Product Change

New versions of Purge connection with manual valve G 1/4 female (Art. No. 109684)

1903-02-00

Dimensions of the new versions:

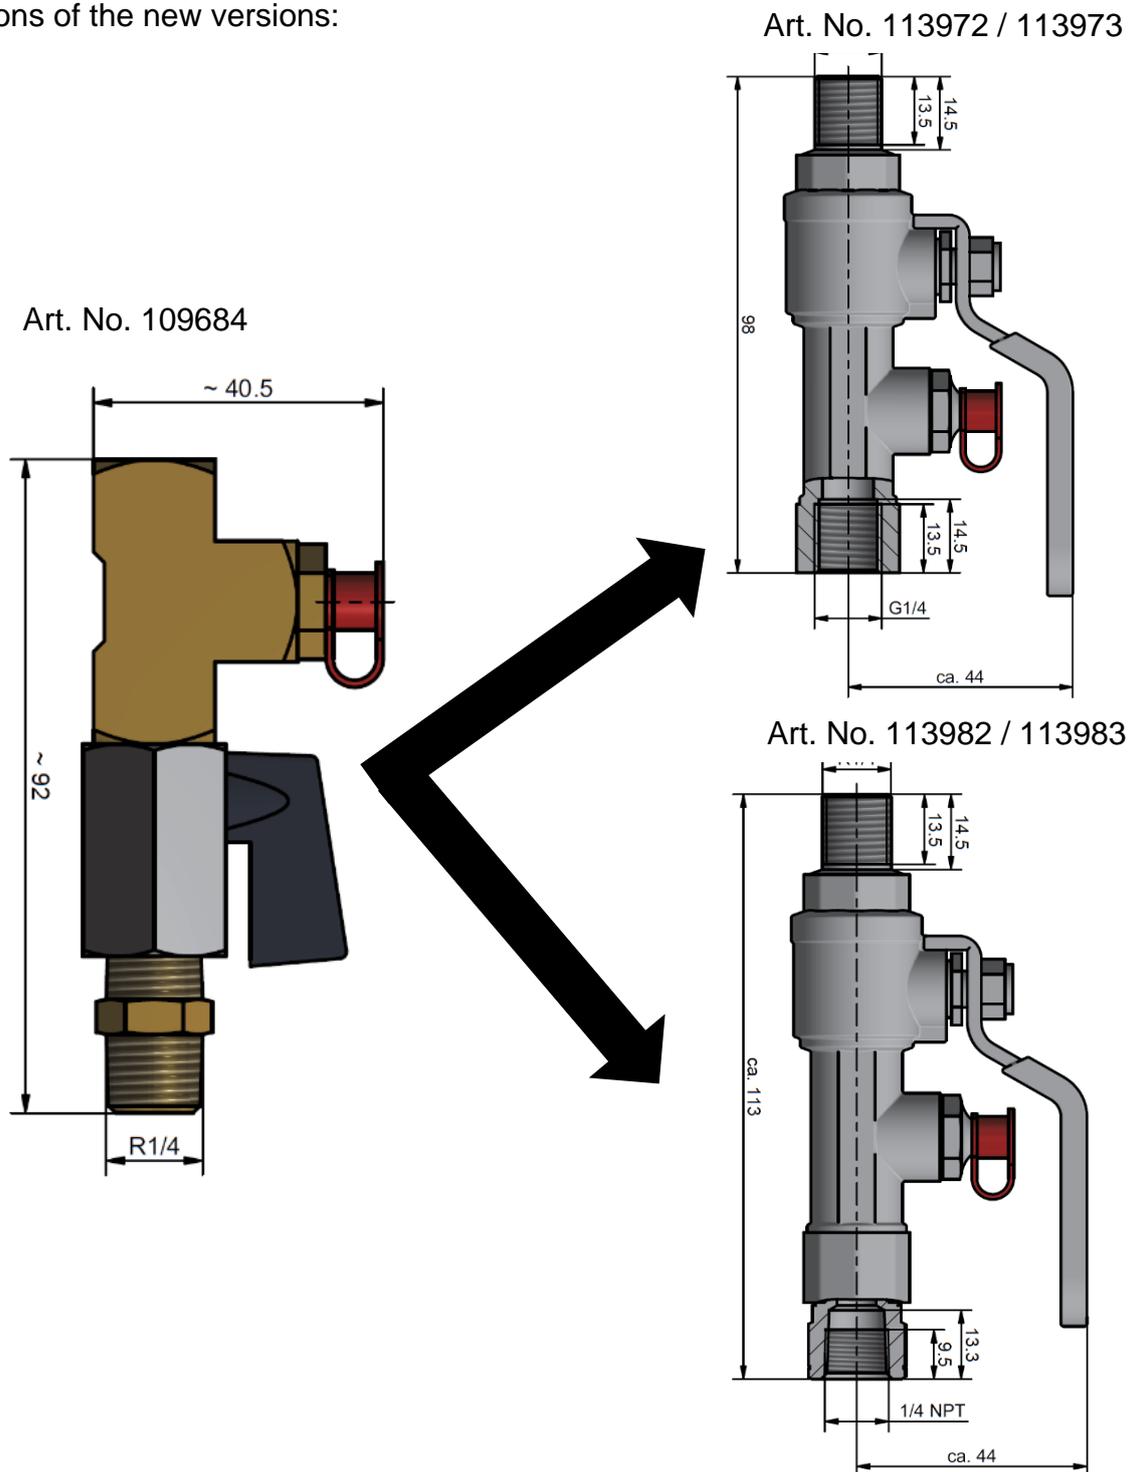
The previous version (Art. No. 109684) is replaced by Art. No. 113972 (brass nickel plated / 1:1 replacement for 109684) and 113973 (stainless steel).

Art. No. 109684
Purge connection with
manual valve
R 1/4 male x
G 1/4 female
(brass nickel plated)

Art. No. 113972
Purge connection with
manual valve
R 1/4 male x G 1/4 female
(brass nickel plated)

Art. No. 113973
Purge connection with
manual valve
R 1/4 male x G 1/4 female
(stainless steel)

Art. No. 113982 (brass nickel plated / 1:1 replacement for 109684) and 113983 (stainless steel) with 1/4 NPT female are available for applications with NPT threads.
